UNITED STATES PATENT AND TRADEMARK OFFICE

Office Action Summary

09/872,563

DETAILED ACTION

FIG. 1A

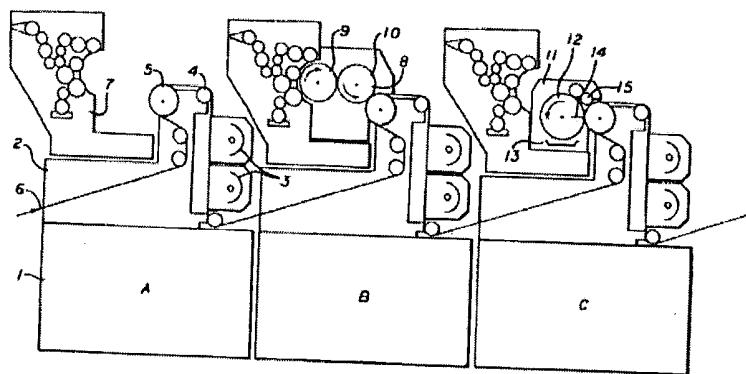
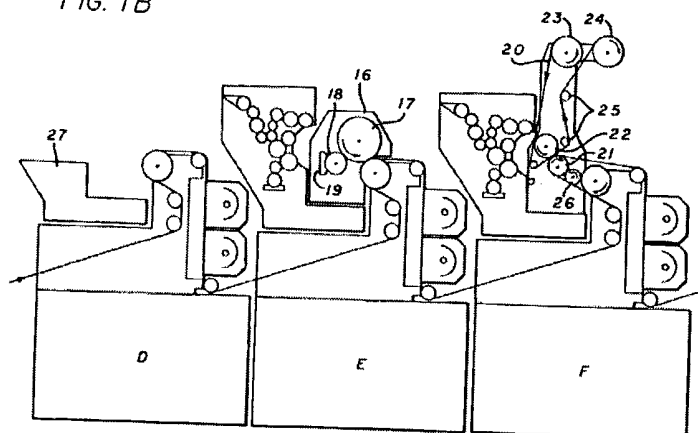
Regarding applicant claim 1, Rasmussen et al. disclose a document printing device comprising (Figures 1A and 1B; column 3, line 46 to column 4, line 38):

- (1) A document creation portions (printing presses) A,B,C,D and E capable of creating a document (printed material) on a medium 6;
- (2) A hot stamp transferring portion (foil relief printer) F capable of providing a transferred foil design on the printed medium 6; and
- (3) A transporting means (not shown) capable of transporting the medium 6 through the document creating and hot stamp transferring portions of the device. The device of Rasmussen et al. is illustrated below:

Rasmussen et al., however, is silent as to the inclusion of a controlling portion for controlling the operation of each of the document creation, hot stamp transferring and transport portions of the apparatus. Nonetheless, it would have been obvious to one of ordinary skill in the art at the time of invention to provide the apparatus of Rasmussen et al. with a controlling means motivated by the fact that it is well-established within the art, and especially so with regards to the modular apparatus such as that of Rasmussen et al., to utilize an over-arching control means to coordinate the operation of each of the printing/transferring modules and transport means. Pensavecchia et al. and Brunner teach examples of such art-recognized control schema. Pensavecchia et al. disclose that such control means enables maintenance of alignment and registration of the printing modules, allows feed back control which can eliminate, or at least reduce, the necessity of ongoing operator manipulation of the process (column 3, lines 59-63). Brunner likewise teaches that such a control means are able to sustain a uniform printing result and results in a regulating process which is more flexible and is kept adjustable by constant adaptation to changing print correlations over long periods of time (column 8, lines 4-9). The control means of Pensavecchia et al. (Figure 1) and Brunner (Figure 2) are illustrated below:

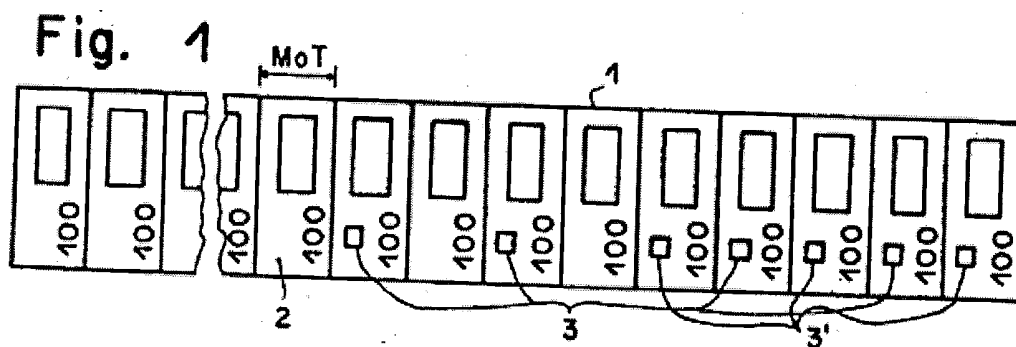
Regarding applicant claim 6, Nyfeler et al. disclose an original document, i.e., a banknote, 1 with an original document indication, i.e., a holographic security stamp, 3, 3' applied by hot foil transfer (Figure 1; column 2, lines 12-64). The original document of Nyfeler et al. is illustrated below:
